ADDENDUM NO. 3

Furnish Replacement Rotary Screw Blowers for the Waste Water Treatment Plant

CITY OF HOMER, ALASKA

Addendum Issue Date: September 29, 2021

CITY OF HOMER, ALASKA - WASTEWATER TREATMENT FACILITIES
MAIN TREATMENT FACILITY
TREATMENT BUILDING 01175
LOWER LEVEL PLAN - SOUTH

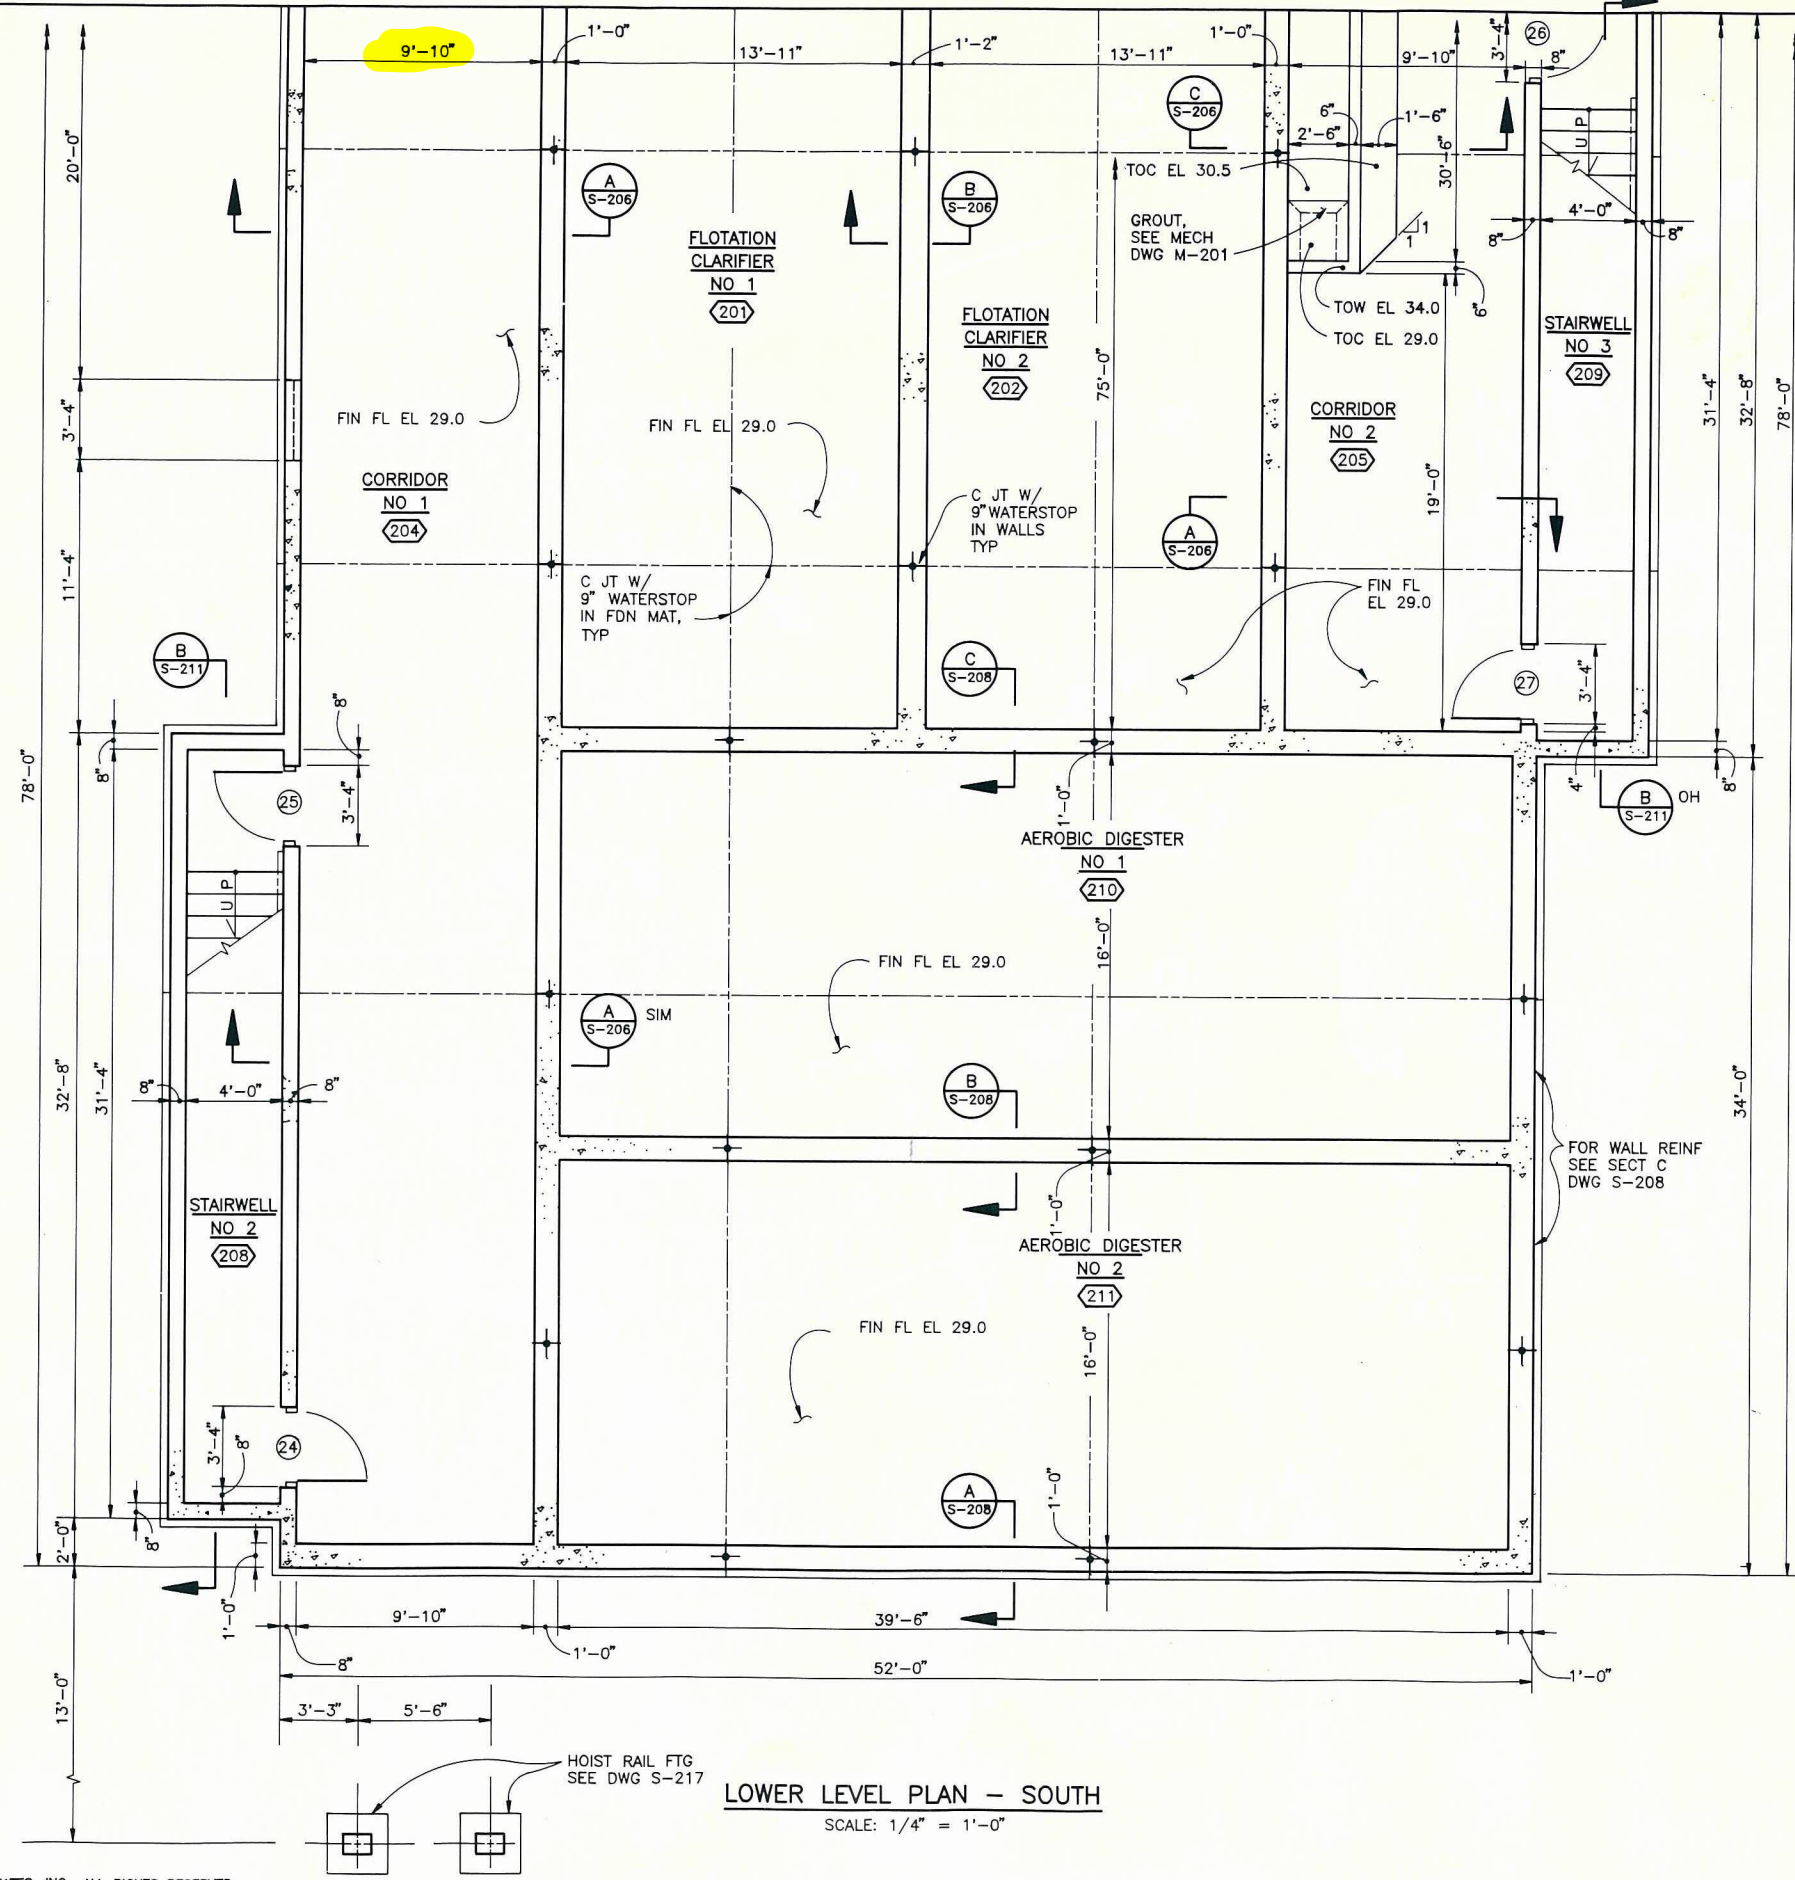
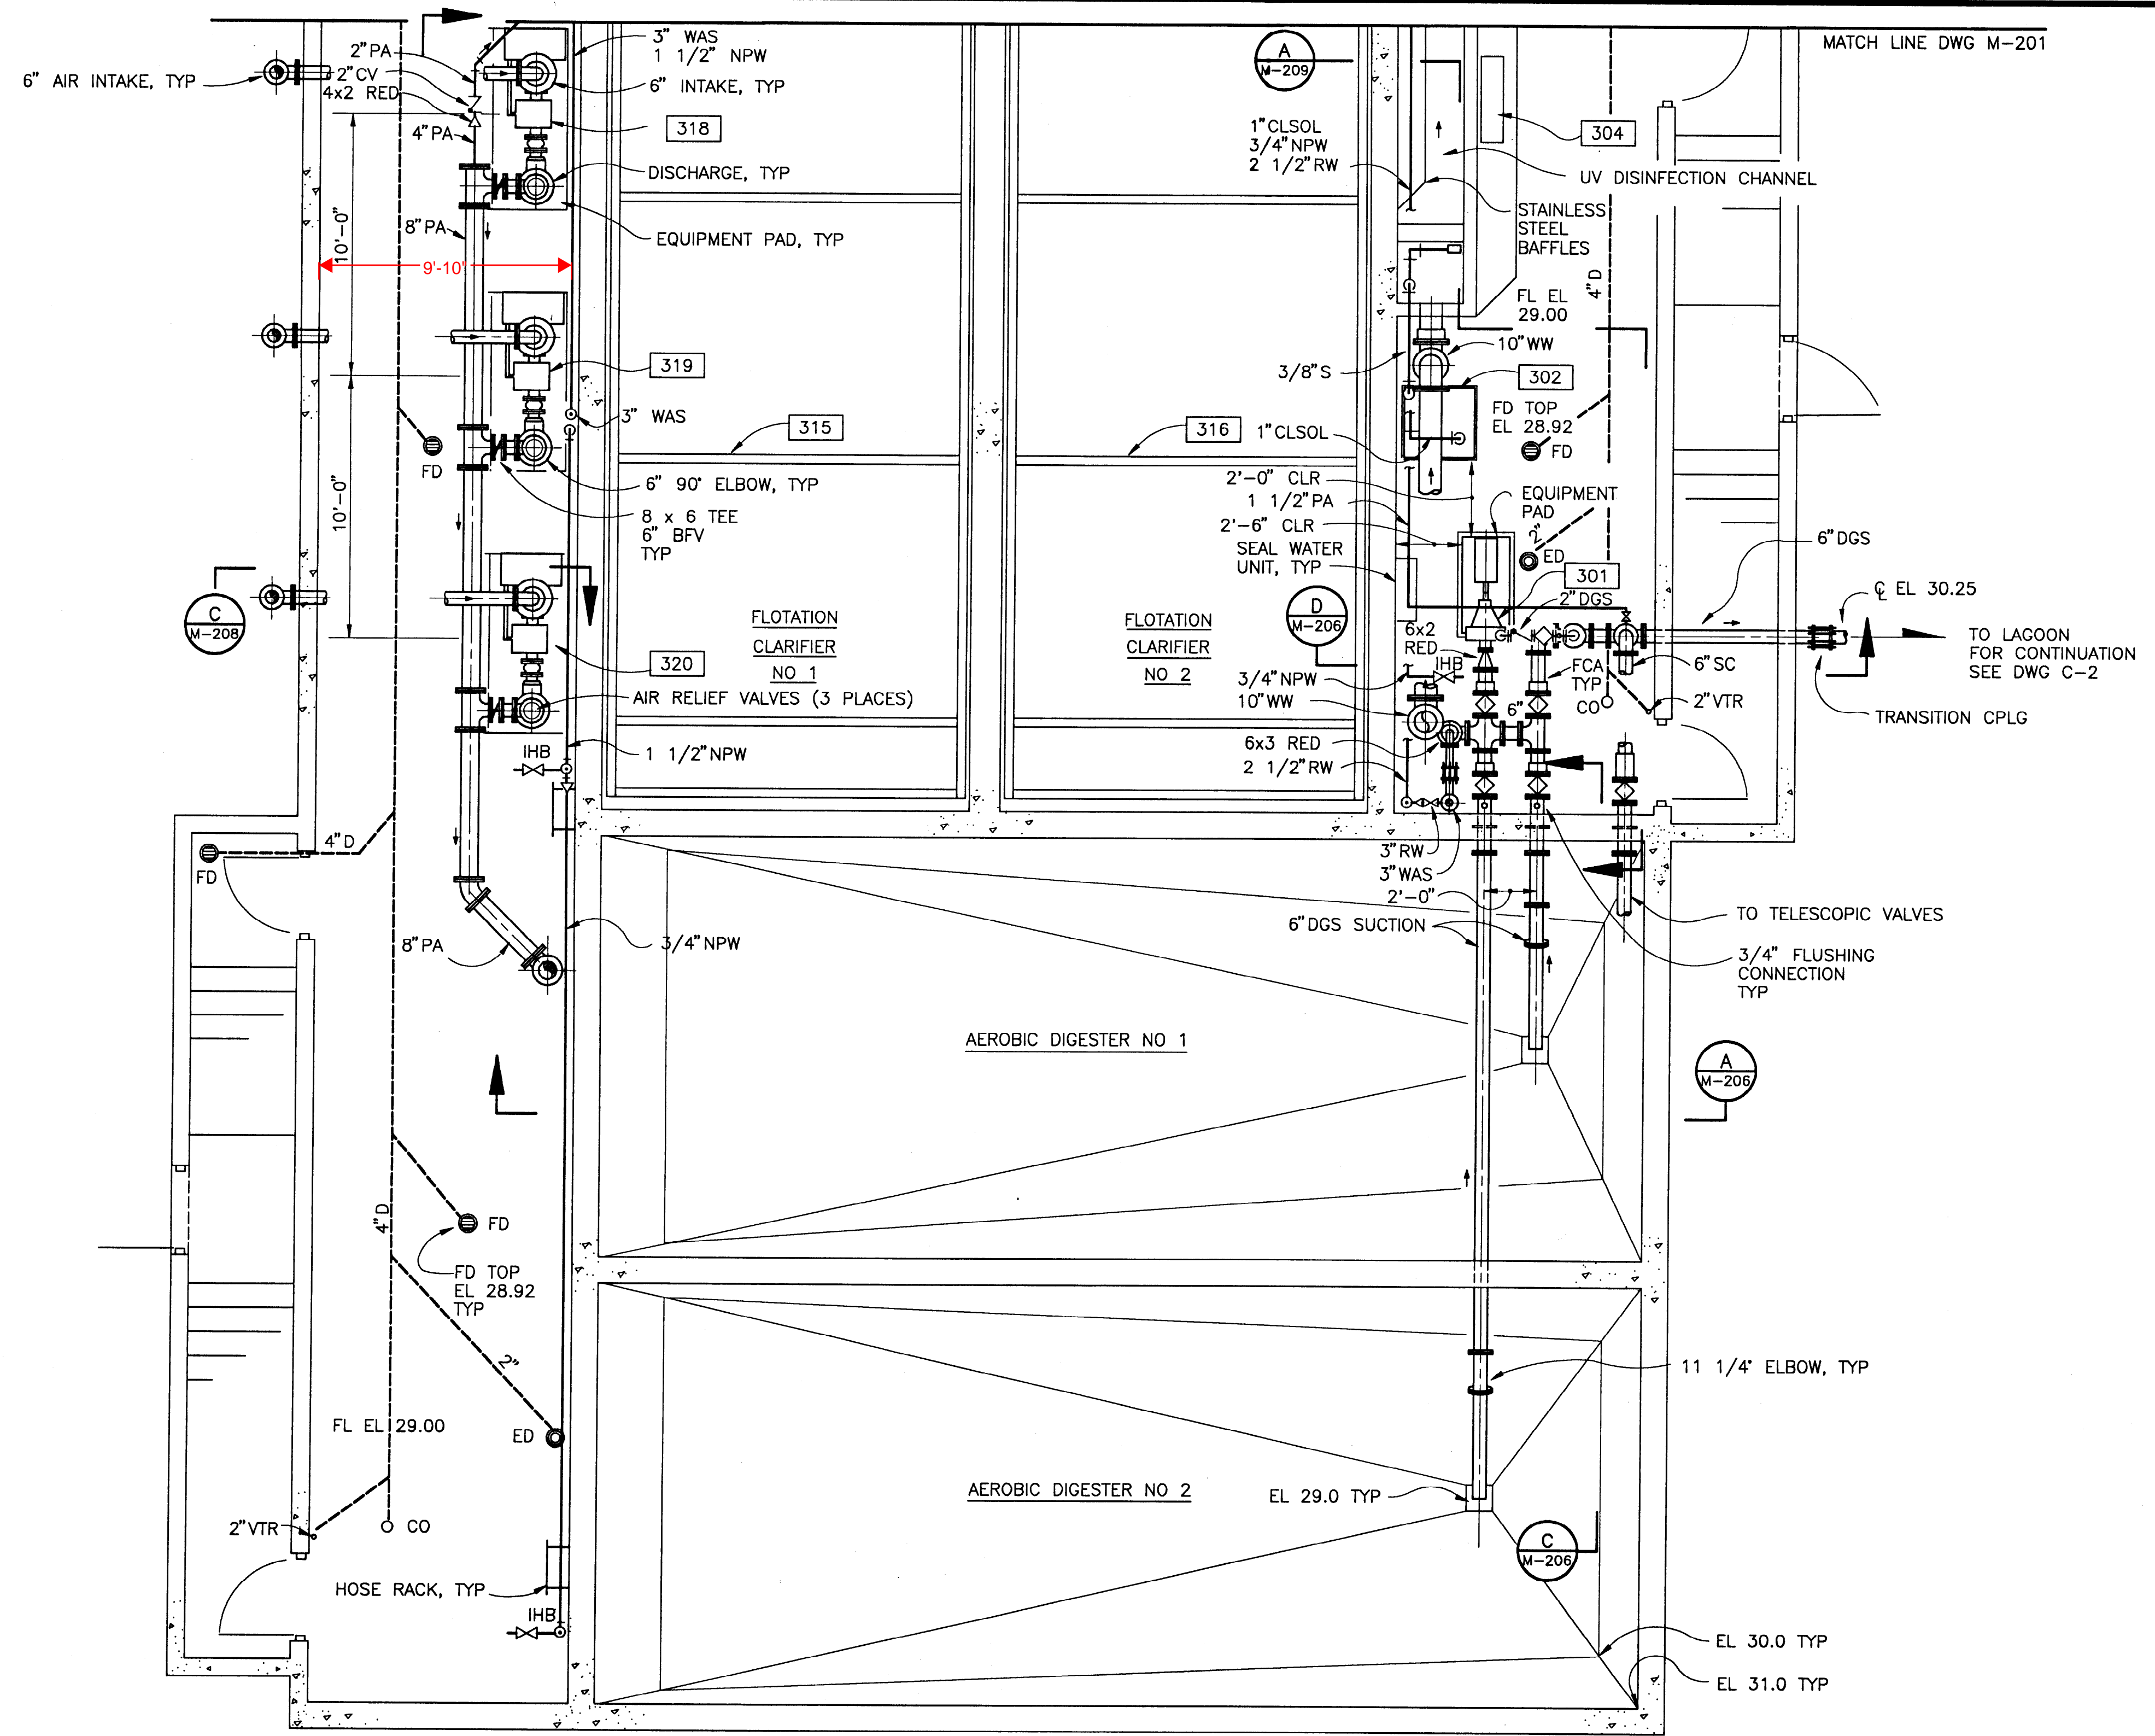
Question #1: Can we get a copy of the plans for the blower room so that we can better figure out how to meet the dimensional requirements?

Answer #1: A copy of the blower room plans is attached to this addendum. The blowers are installed in a hallway that is less than 10 feet in width as depicted in the attached drawings. In addition to housing the blowers, the hallway also serves to provide access to other critical equipment. The dimensional requirement is driven by the need to be able to access and/or move critical equipment through the hallway.
